February 2, 1977  
L-77-38

Re: Turkey Point Units 3 and 4  
Docket Nos. 50-250 and 50-251  
ECCS Reevaluation  
Supplemental Information

Re: Turkey Point Units 3 and 4  
Additional ECCS Information

FIGURE 1

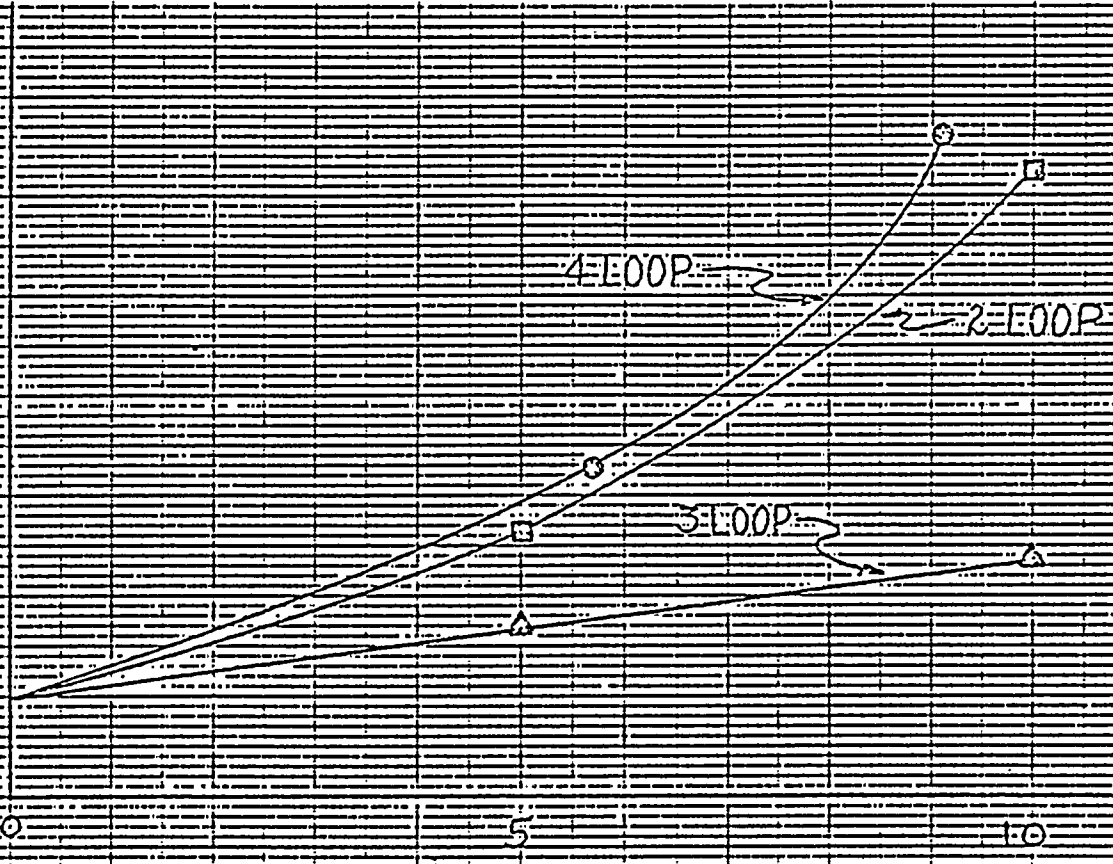
QUESTION: Justify that the peak clad temperatures corresponding to different percentages of plugged steam generator tubes can be obtained by a linear interpolation, and submit a basis for the dependence of  $F_q$  on steam generator plugging.

ANSWER: Sensitivity studies were performed by Westinghouse in the early part of 1976 to determine, on a generic basis, the effect of plugged steam generator tubes on peak clad temperature (PCT) calculated during a LOCA. Three sets of runs were made, 1 each for a 2 loop plant, a 3 loop plant, and a 4 loop plant. The results were summarized and presented at an ACRS ECCS Subcommittee meeting. Plots of the results are shown in Figure 1. Figure 1 shows that the curves of  $\Delta PCT$  versus percent tube plugging are concave upward, which means that linearly interpolating between any two plugging levels results in a higher, or conservative, value of  $\Delta PCT$ .

FIGURE 12 ACCUMULATOR WATER VOLUME, 825 FT<sup>3</sup> ...

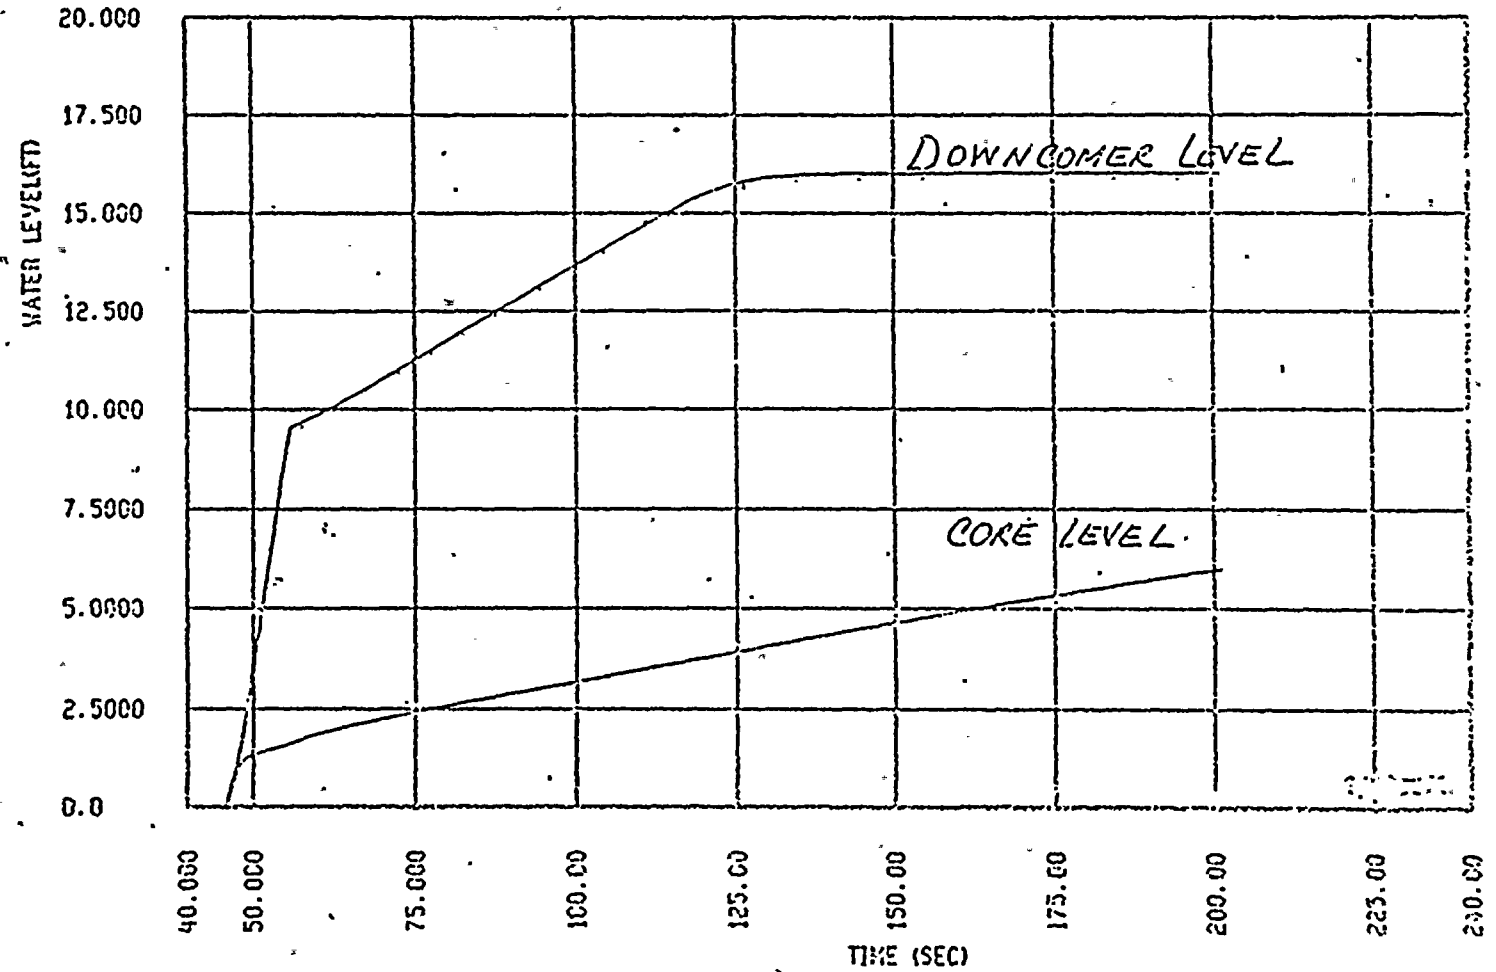
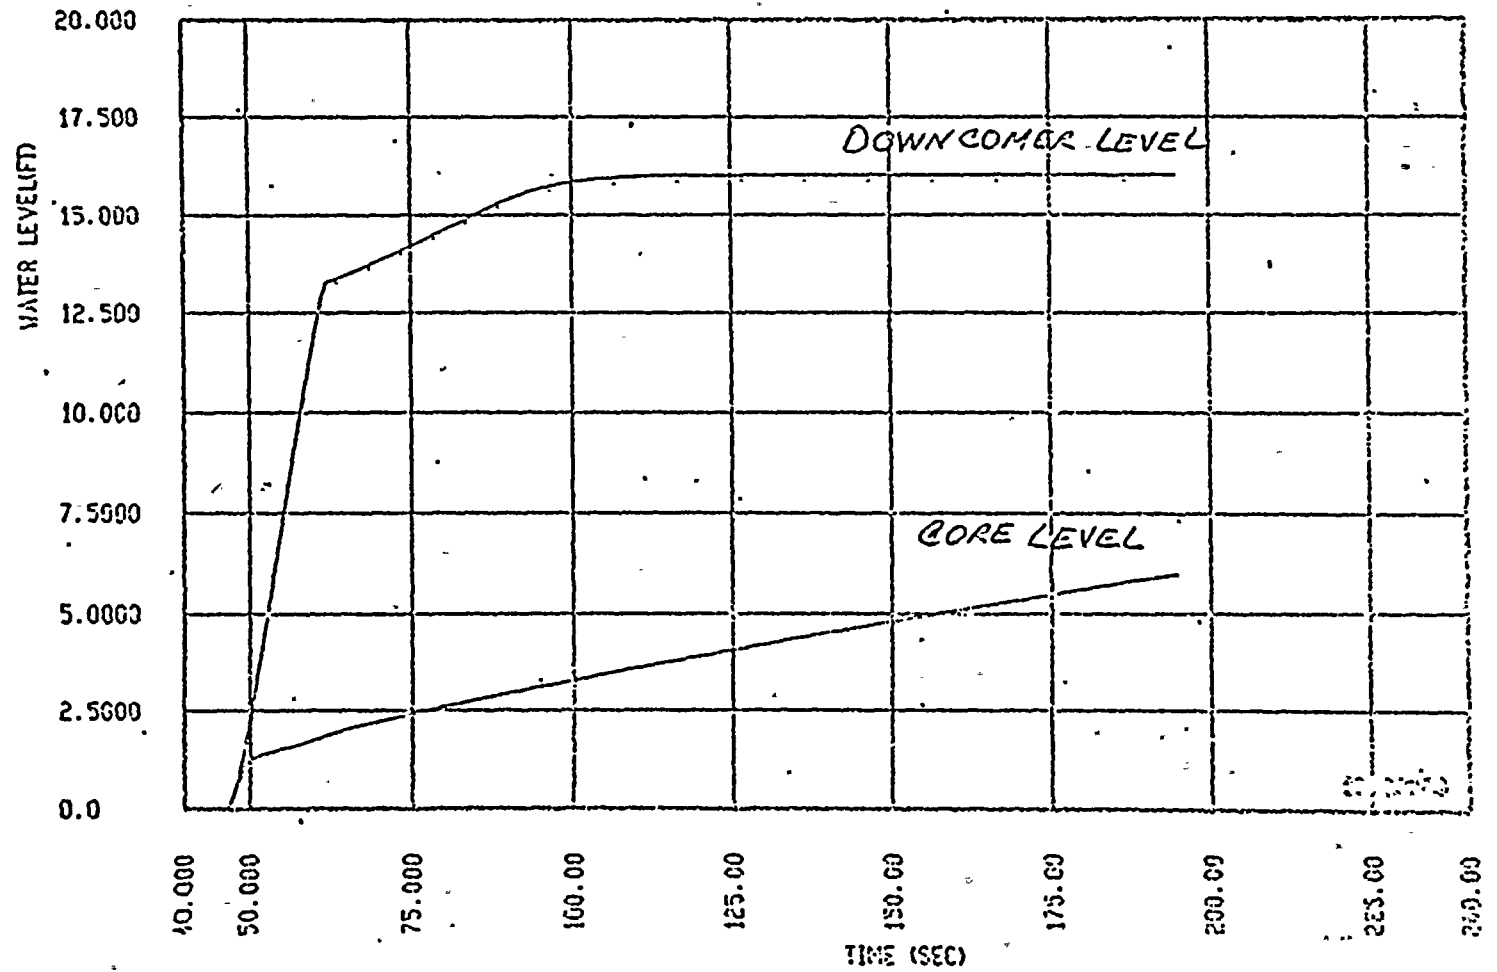
QUESTION: Submit the Westinghouse ECCS analyses which show that the decrease in accumulator water volume from 875 cubic feet to 825 cubic feet corresponds to 36°F rise in PCT.

The effectiveness of accumulators can be studied by inspecting Figures 1a and 1b, which are the downcomer water level and core water level plots, and Figures 2a and 2B, which are the core reflood water inlet velocity plots. The optimum accumulator water volume, based on previous studies, is generally a value that results in the downcomer being "almost" full when the accumulators empty.

From Figure 1a, when the accumulators empty, the downcomer height is about 9.5 feet for an initial water volume of 825 cubic feet per tank. Figure 1b indicates that increasing the initial water volume to 875 cubic feet per tank results in the downcomer being filled to 13.3 feet when the accumulators empty. This difference in accumulator performance during the accident results in a decrease in PCT from 2194°F for the core using 825 cubic feet initial accumulator water volume per tank to 2158°F for the case using 875 cubic feet.
